## SERVICE BULLETIN

**APPLICABILITY:** 2014MY Forester NA Models **NUMBER:** 02-147-13  
**SUBJECT:** Revised Valve Train Parts to Reduce a Warm Engine Tapping or Sewing Machine type Sound from the Left Cylinder Head **DATE:** 10/28/13

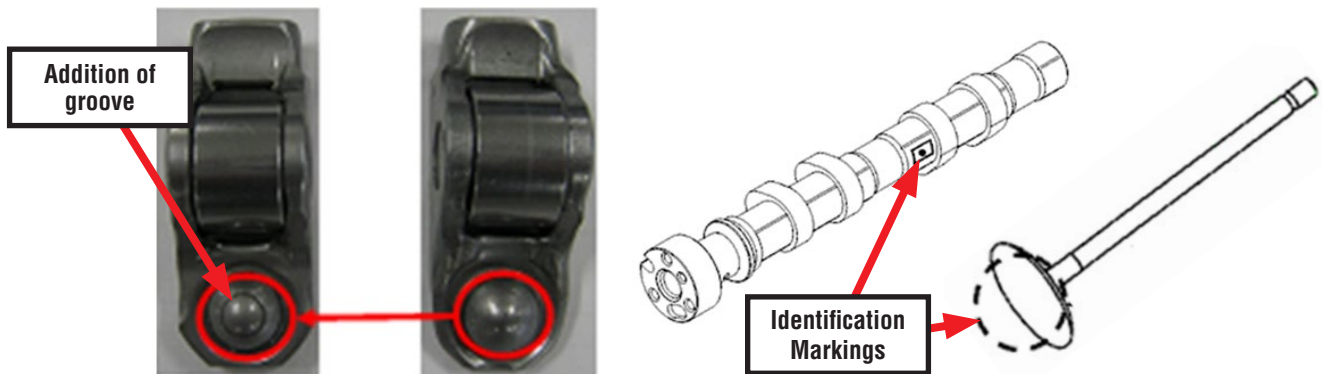
This bulletin announces the availability of revised valve train components developed to reduce a tapping type sound which may be heard coming from the left-hand (B2) side of the engine when the engine is warm. This bulletin does not address any cold engine or start-up type sounds. The changes consist of:

- Design change to the valve rockers
- Camshaft profile change
- Increased intake valve stem length (1.65mm longer Intake, 2.4mm longer Exhaust)

The illustrations below show additional information about the changes to the valve rockers, camshafts and valves to help readily distinguish them from the previous version parts.

PART NAME		NEW	OLD
VALVE ROCKER	Part Number	13249AA250	13249AA240
	Change	Change to roller portion	-
	Identification	Circular groove added on pivot side	No groove
CAMSHAFT INTAKE, LEFT	Part Number	13037AA960	13037AA850
	Change	Cam profile change	-
	Identification	38B360 or 38B410	38B250 or 38B300
CAMSHAFT EXHAUST, LEFT	Part Number	13052AA960	13052AA850
	Change	Cam profile change	-
	Identification	53B360 or 53B410	53B250 or 53B300
